30
Shearon Harris Nuclear Power Plant
Draft SER Open Item No. 354
NRC Question 210.65

Piping Stress Analysis Data, Allowable Flange Moments

Shearon Harris Nuclear Power Plant
Draft SER Open Item No. 354
NRC Question 210.66

AUX. BLDG UNIT 1 OBE N-S

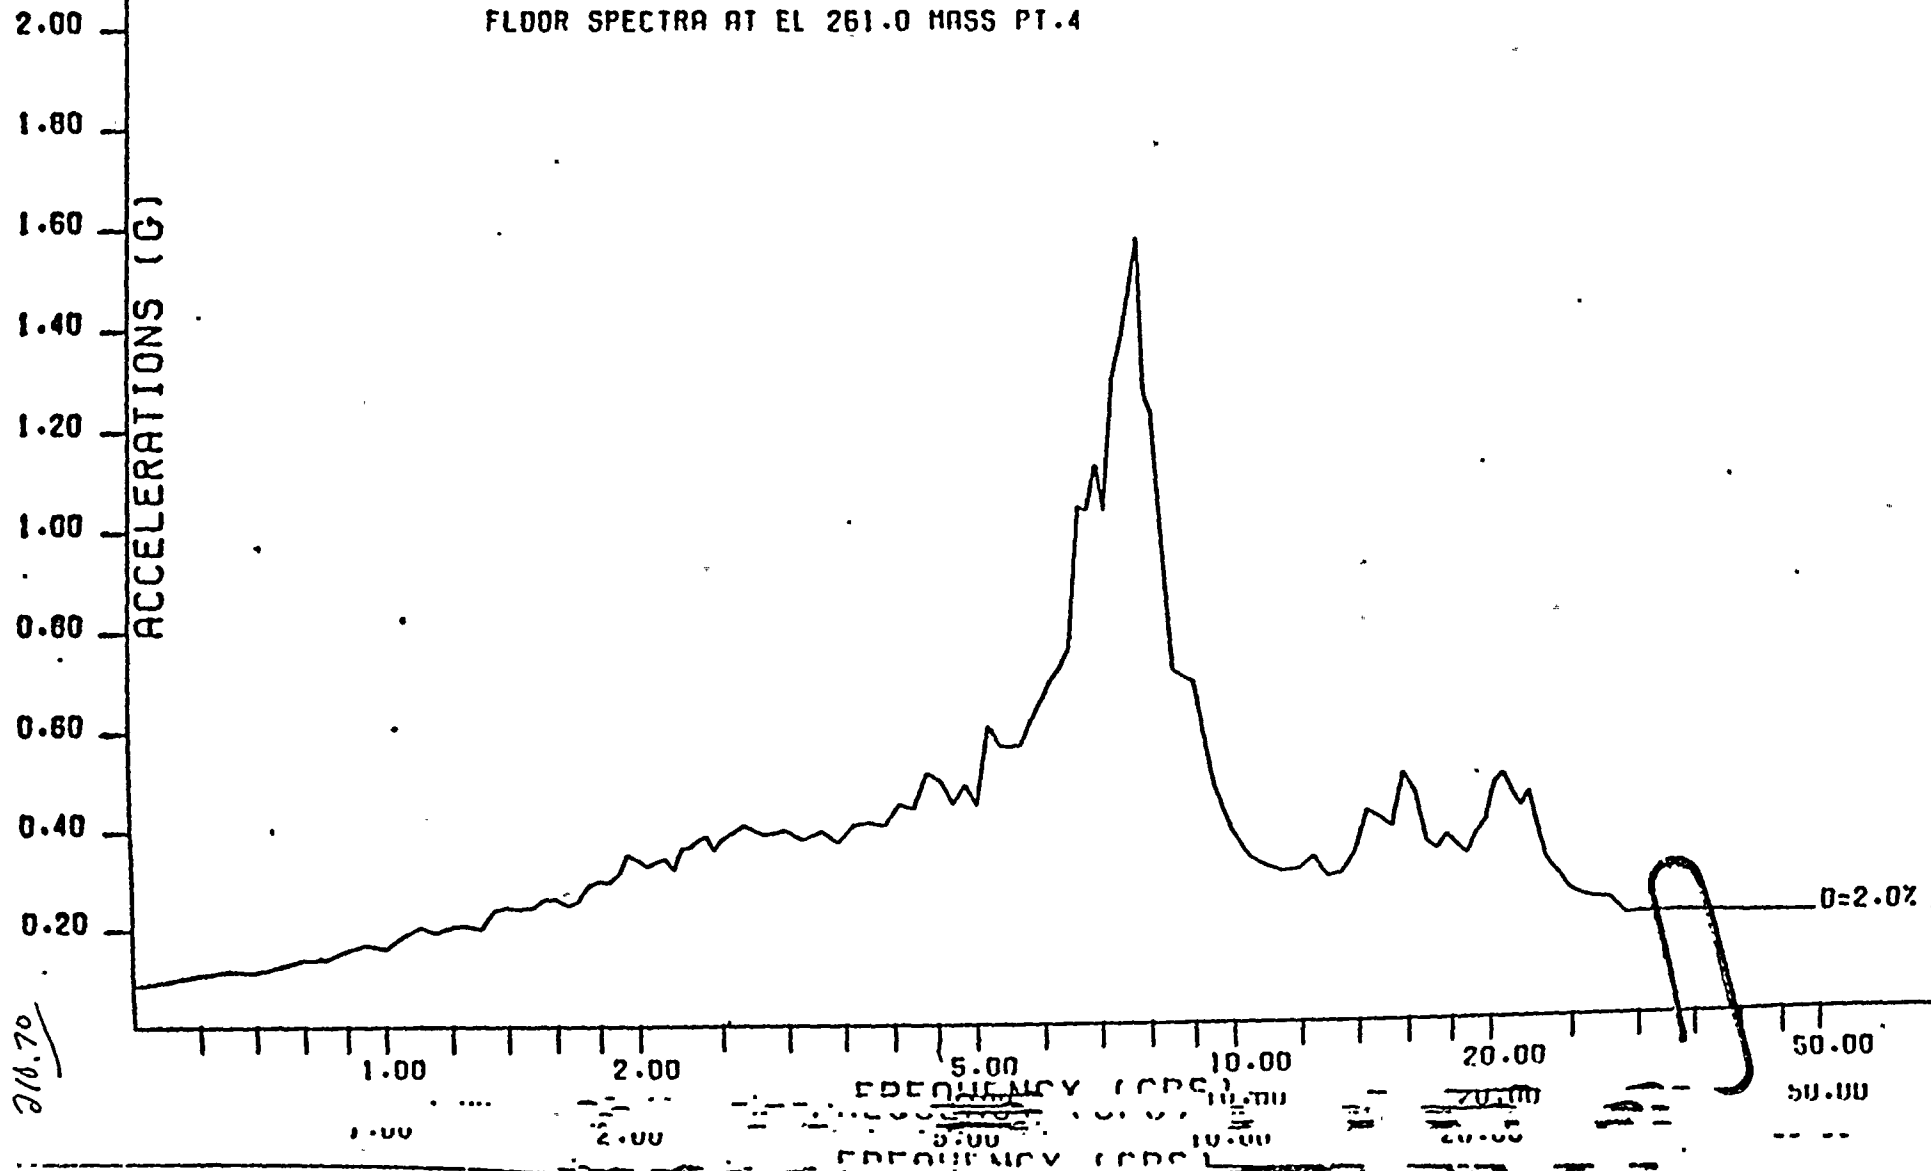
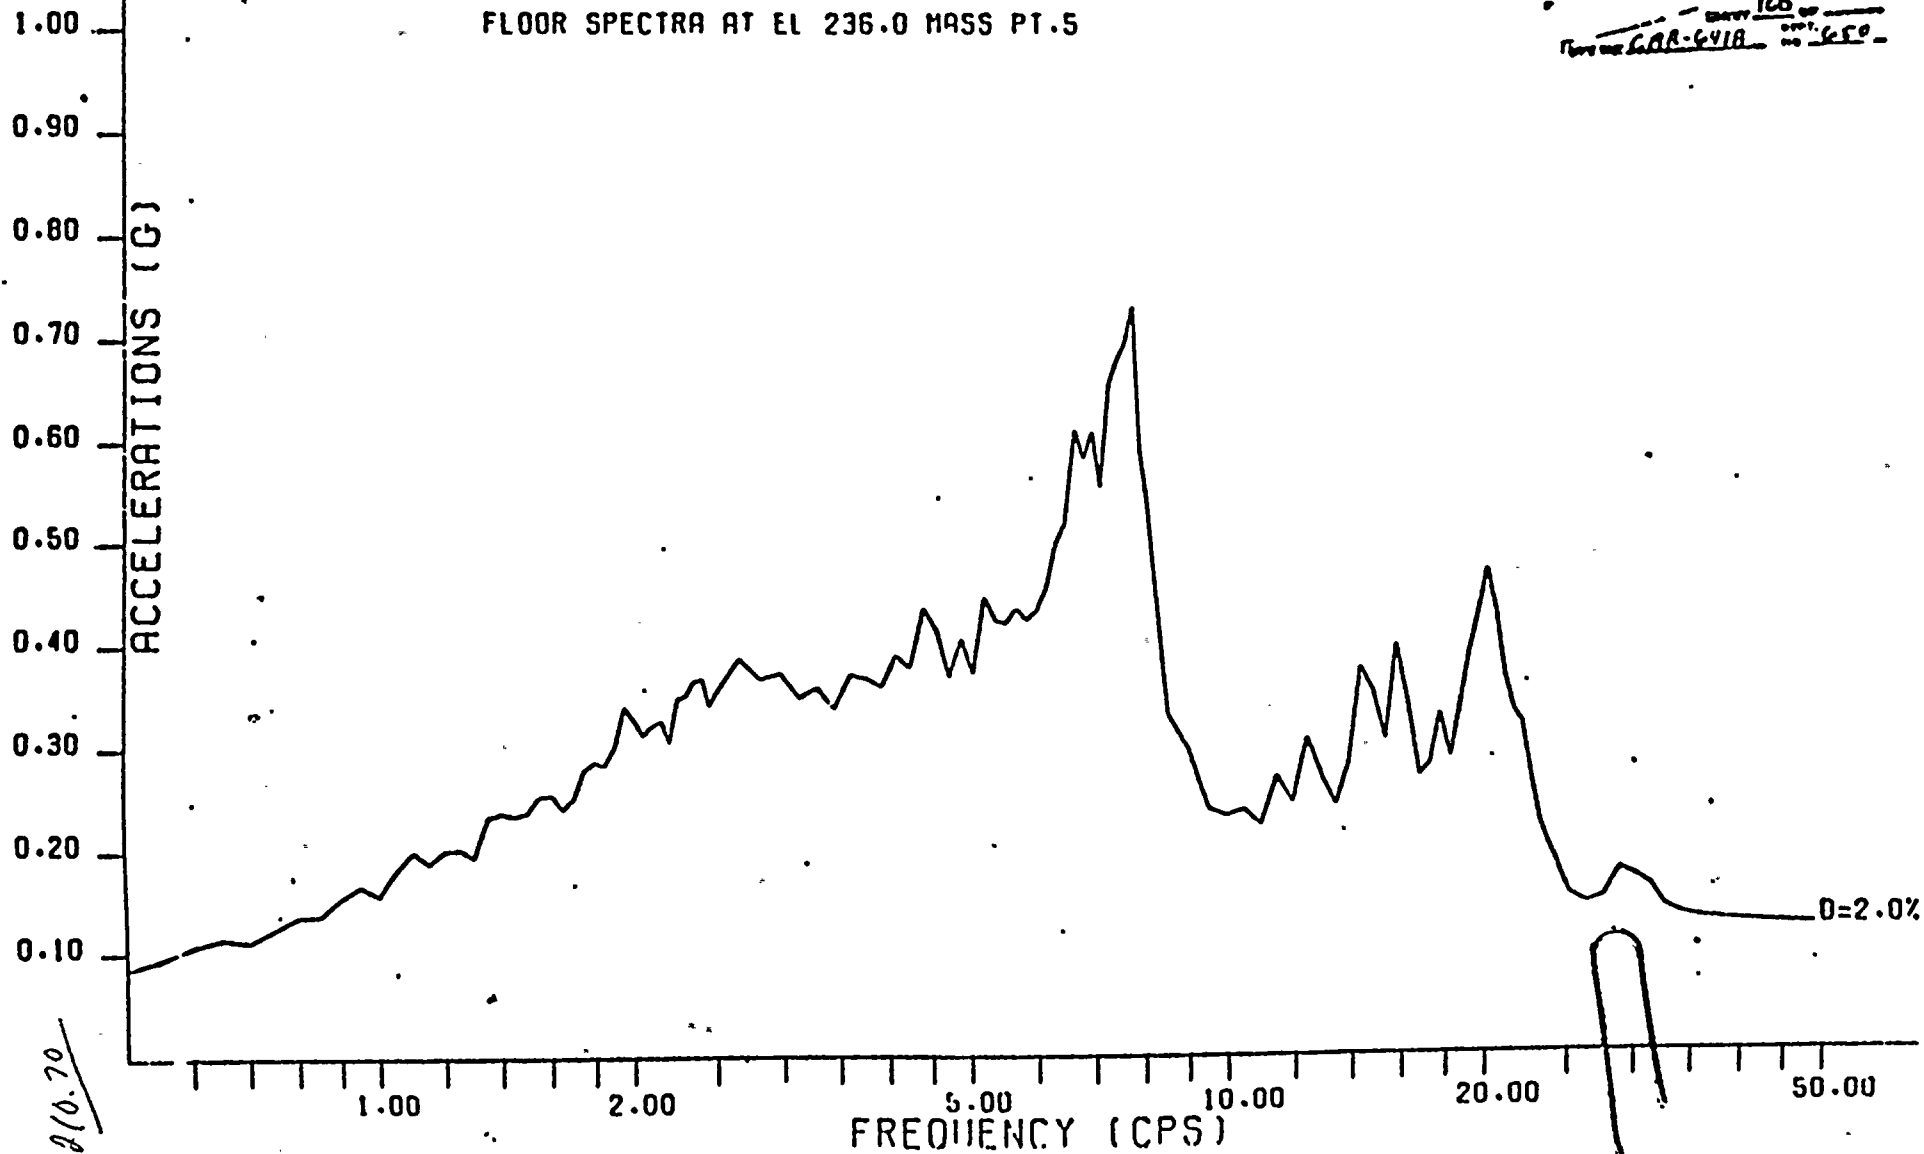
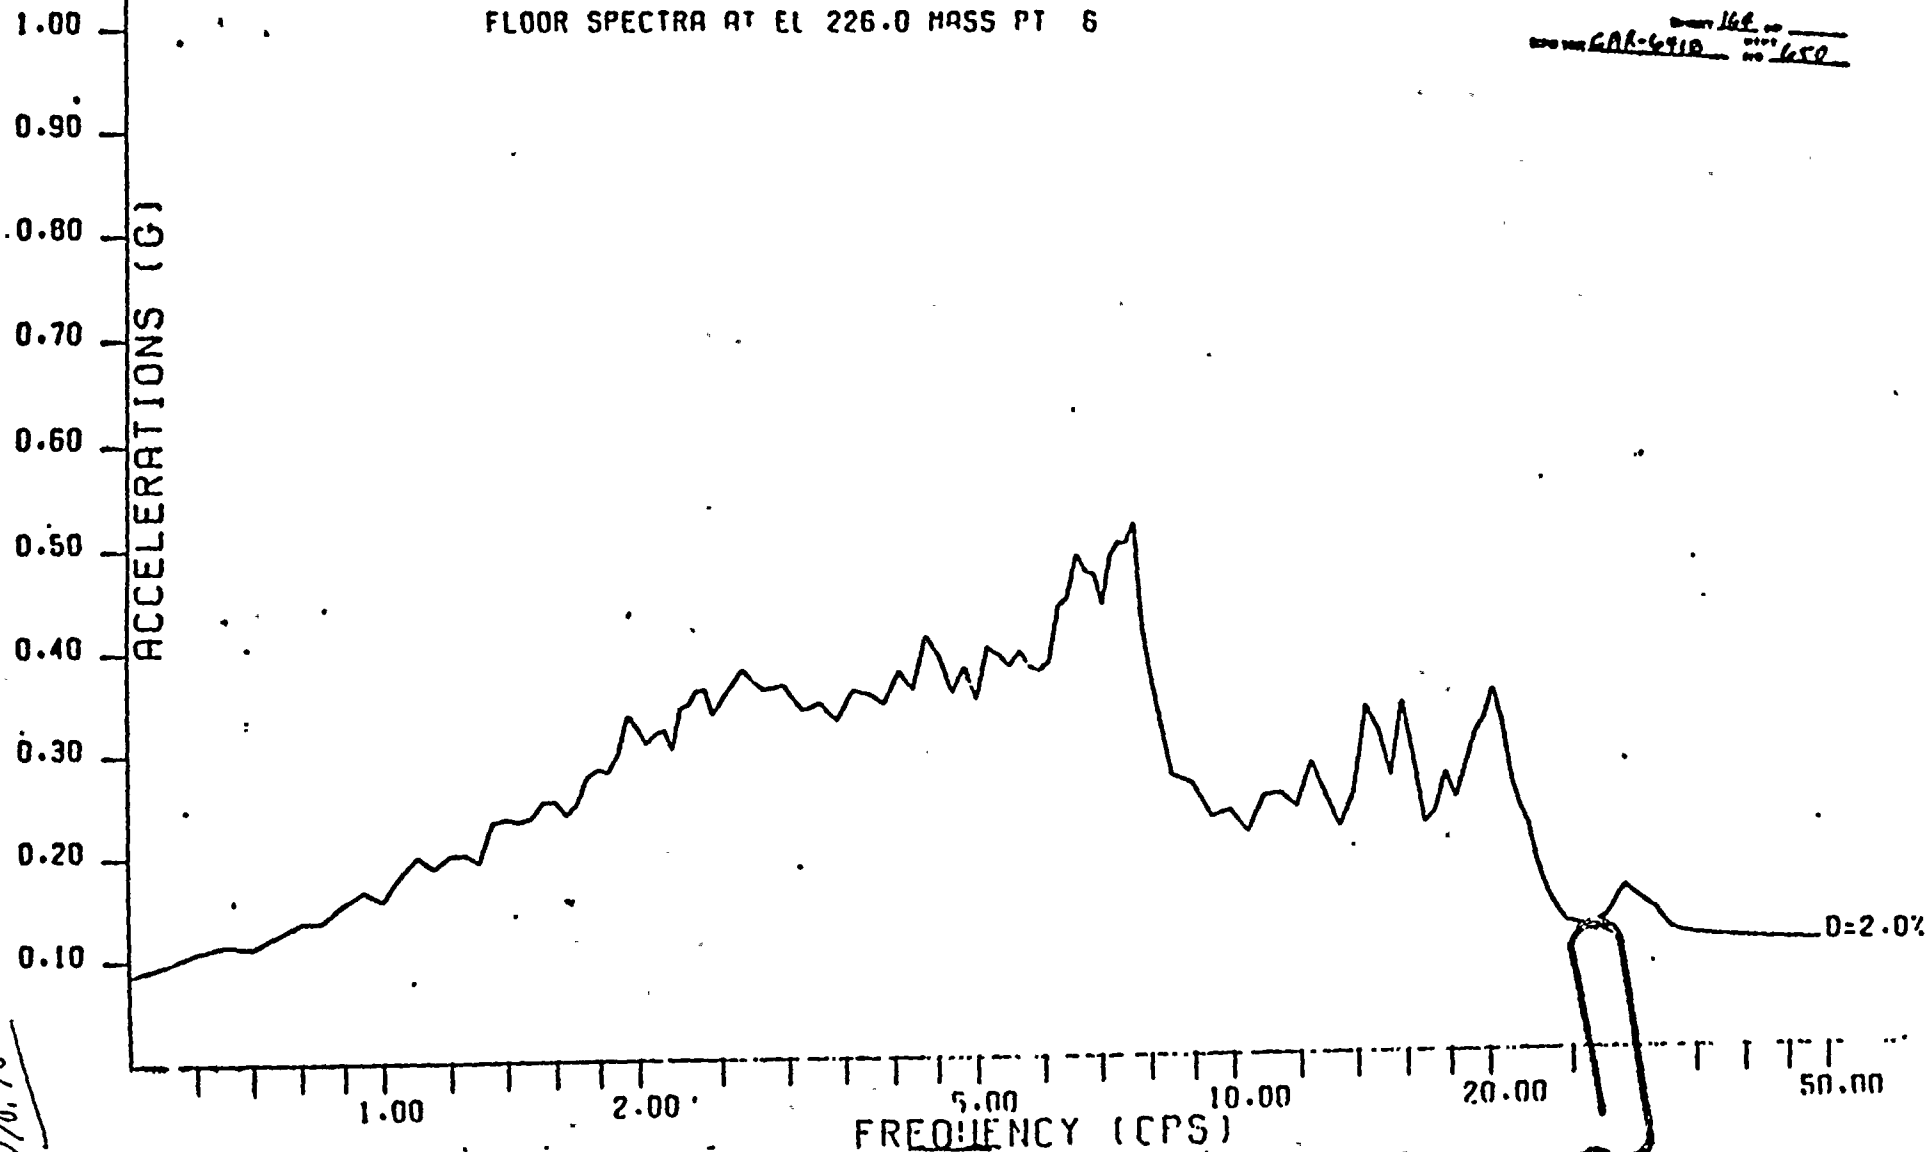
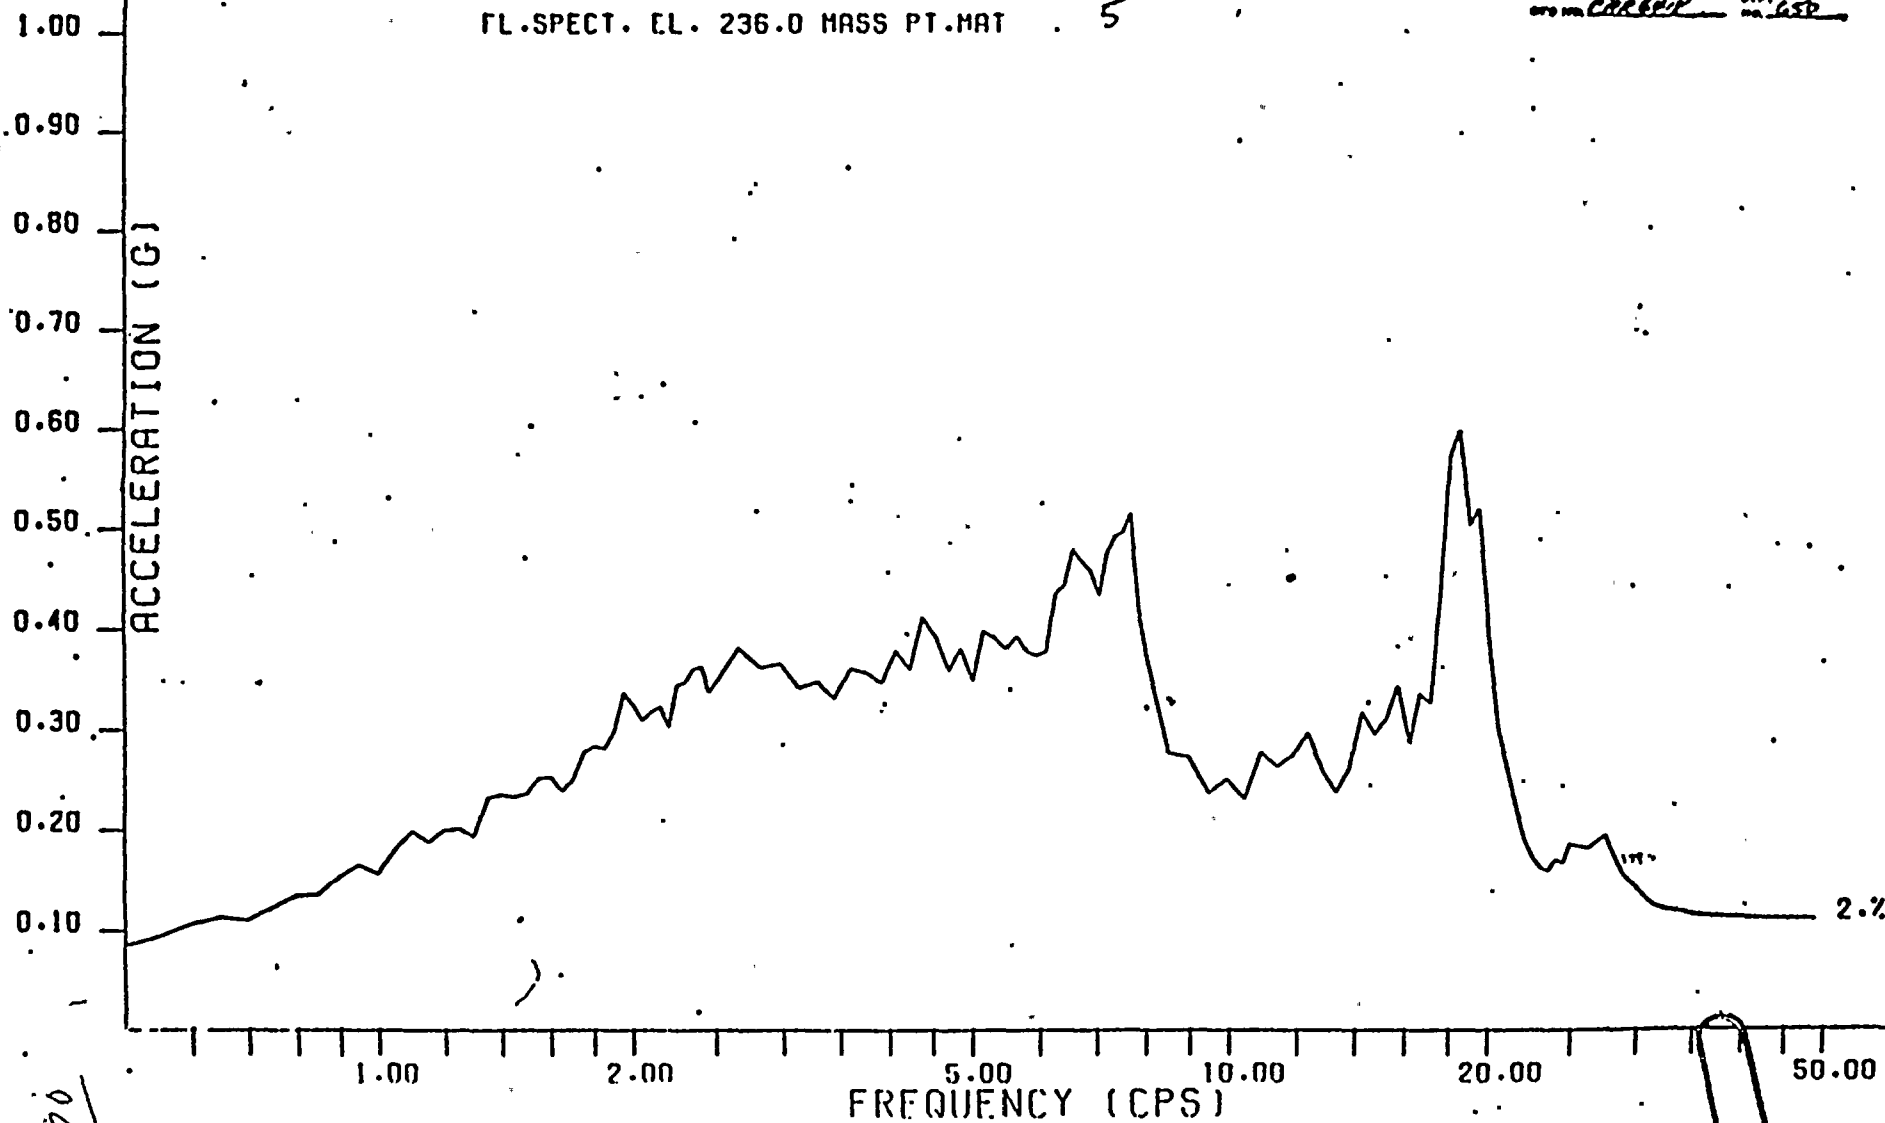
Where does the Specification CAR-SH-M-30, Rev. 16 give instructions on how to select the specific seismic input data for piping system analyses? Appendix F, "Seismic Consideration for Mechanical Equipment" is included in the Specification but we have not seen any reference to it in the text of the Specification. For example, Appendix F is not referenced in 3. of Part I or in 23.01 or 23.03 of Part II. Further, 2. of Appendix F says that "Safe shutdown earthquake loads for all equipment (except as noted in the specification) are obtained from the attached Floor Response Spectra Curves for Horizontal and Vertical Excitation." The "attached" curves are labeled "Typical . . . Spectra" and, despite what Appendix F says, we assume that these are not the spectra used in, for example, Calculation No. 8050-1.

The instructions regarding the specific seismic input data for piping system analyses are given in Ebasco Design Specification for Piping, CAR-SH-M-71. Paragraph 6.11a of this specification states: "All piping covered by this specification is classified as Seismic Category I which shall be analyzed utilizing the response spectra curves and computer output sheets provided in Appendix A of this specification and the seismic criteria set forth in the FSAR."

As a sample, we are enclosing for your information and use, the OBE North-South response spectra which was subsequently enveloped for Calc. No. 8050-1.

FIG. 1 NOMENCLATURE ILLUSTRATION

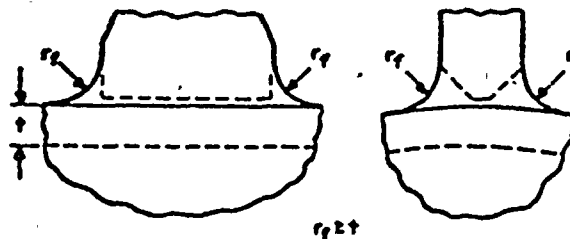
When shear lugs or fabricated lugs are used, how are the stresses due to these attachments evaluated? See NC3645 (1971) and (1980).

The stresses for shear lugs and fabricated lugs are evaluated based on the enclosed procedure. This procedure complies with the requirements of the Welding Research Council Bulletin No. 198. The attached procedure was incorporated into the pipe hanger fabricator (Bergen-Paterson) welded pipe attachment program and is called BPLUG. This procedure is used for evaluating run pipe stresses due to integral lug attachments. Stresses within the run pipe wall due to the integral lug attachment can be found by a review of that procedure.
